APPENDIX C
AREA WALK-BY CHECKLISTS (AWCs)

Area Walk-By Checklist (AWC)

Room 105 Floor El. 545 Bldg. AUXB

Photo 2
Missing Nuts on Cover of E31-4

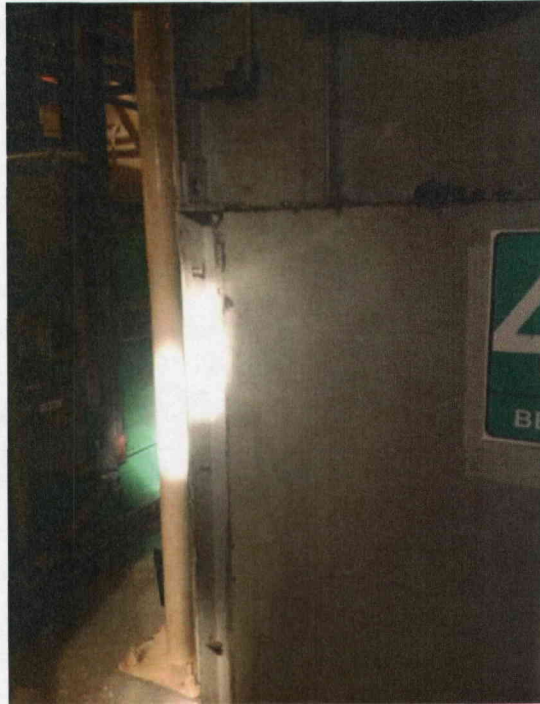
<i>Anchorage for cover plate of E31-4 does not have nuts, see Photo 2. Concern has been judged not to represent an adverse condition regarding the component's seismic performance.</i> | X | | | |

Photo 3
Temporary Scaffolding Restrained

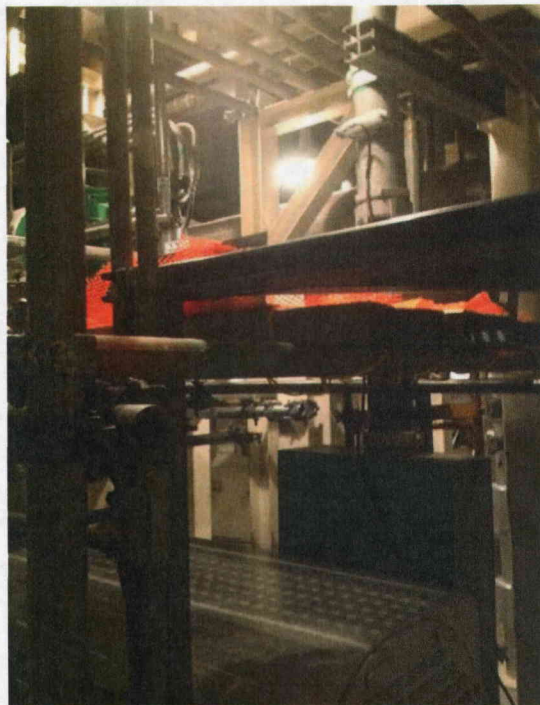
Temporary scaffolding in area appears to be adequately restrained. See Photo 3.

Photo 1
General View of Room 328
Masonry Wall Adjacent to Heat Exchange E22-1

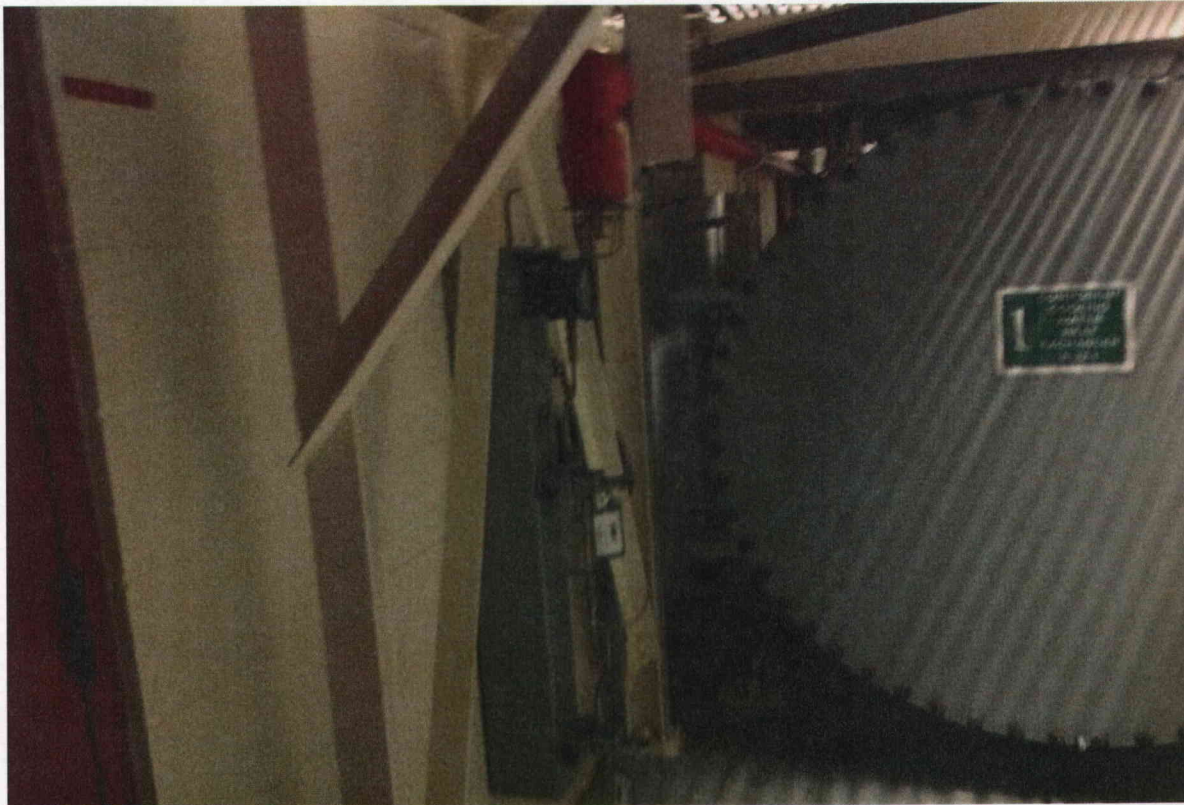
*Need to verify anchorage of E 22-1 (welded?)
Anchorage confirmed to be consistent with design documentation.*

Photo 2
Crack in Masonry Wall

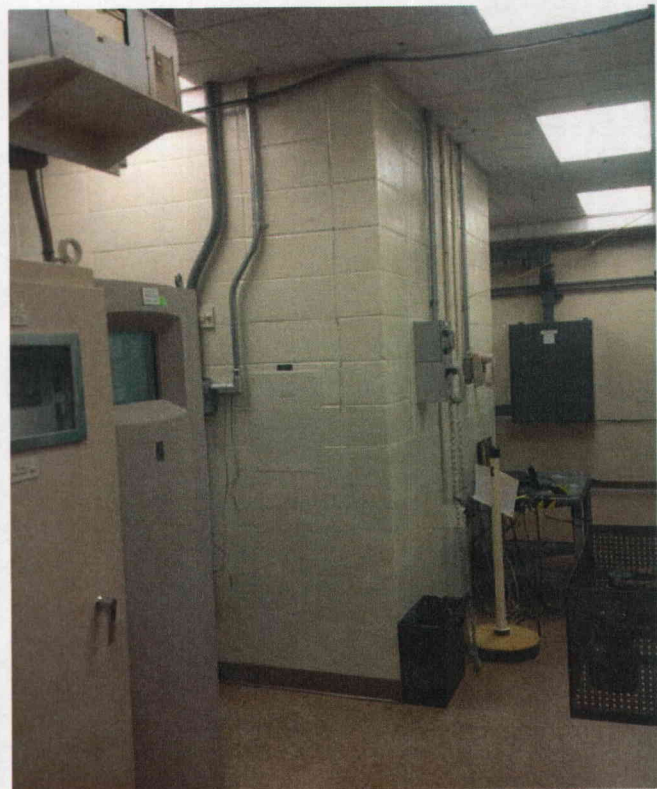
Masonry walls in area. Verify seismic adequacy of walls
